# SERVICE BULLETIN

NACELLE - EXHAUST - THRUST REVERSER, UNIQUE V2500-A5 CONFIGURATION - REIDENTIFICATION
OF - CATEGORY CODE 6 - MOD.NAC-78-0095

V2500-NAC-78-0095

Left Half Thrust Reverser with Two (2) Vent Holes Fig.1

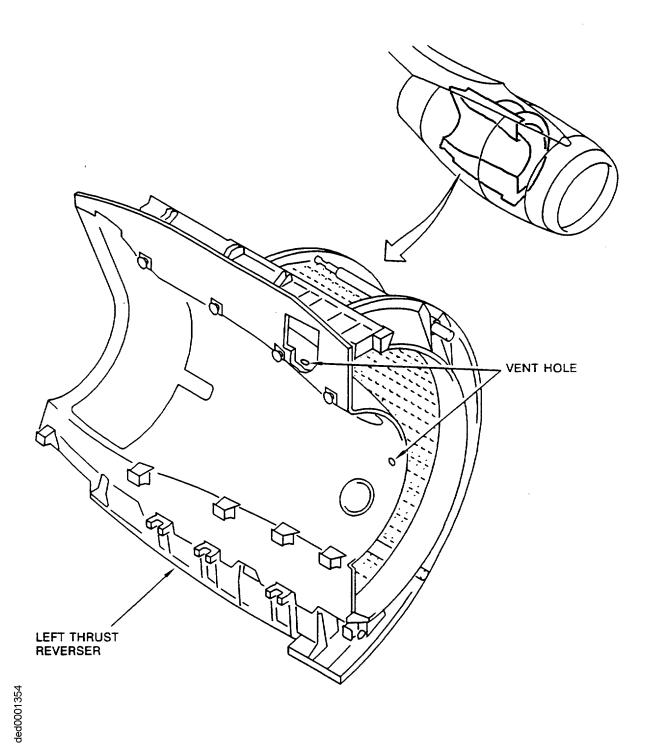
- B. Rework or Modification Instructions Thrust Reverser Left Half
  - (1) Find inner barrel area on 740-0002-713 or -715 left thrust reverser door.
  - (2) Make sure the thrust reverser door and 740-0220-297 forward heatshield have two additional vent holes. Refer to Figure 1. If additional vent holes are not in thrust reverser doors and forward heatshield, refer to IAE Service Bulletin V2500-NAC-78-0087.
  - (3) Reidentify 740-0220-297 forward heatshield to 745-0220-1 with rubber stamp and black ink (CoMat 06-073). Refer to IAE V2500 Standard Practices/processes Manual, Chapter 70-09-00.
- C. Post requisite Instructions

Nameplate Fig.2

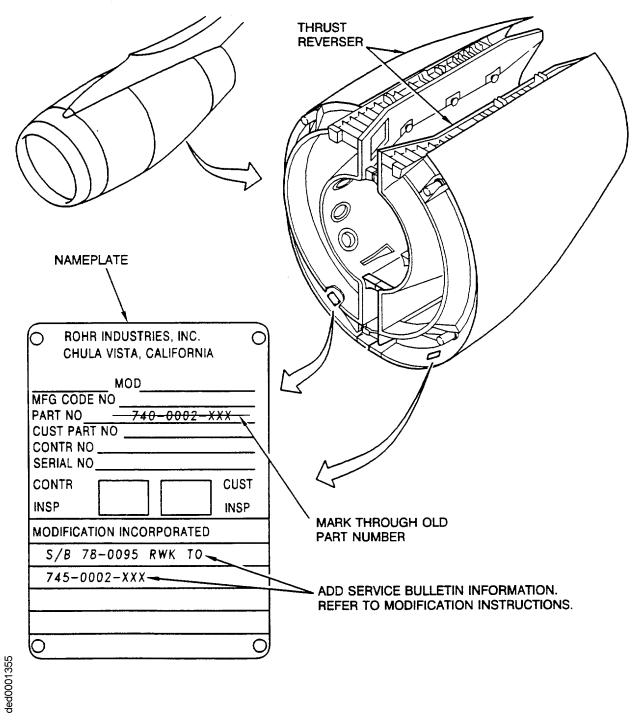
- (1) Find nameplate on forward lower area of left thrust reverser door. Refer to Figure 2.
- (2) Make a mark through 740-0002-713 or -715 part number on nameplate.
- (3) Add "S/B 78-0095 RWK to 745-0002-501" to nameplate for 740-0002-713 and "S/B 78-0095 RWK TO 745-0002-505" for 740-0002-715 with metal stamp, electroetch, or vibroetch method. Refer to IAE V2500 Standard Practices Manual, Chapter 70-09-00.
  - NOTE: Right thrust reverser doors 740-0002-705 and -707 are interchangeable with 745-0002-503 and -507 right thrust reverser doors. Production doors will be numbered with "745 prefix" type part number to help identify the difference between V2500-A1 and -A5 doors. See Section 3. Material Information for applicable part numbers.
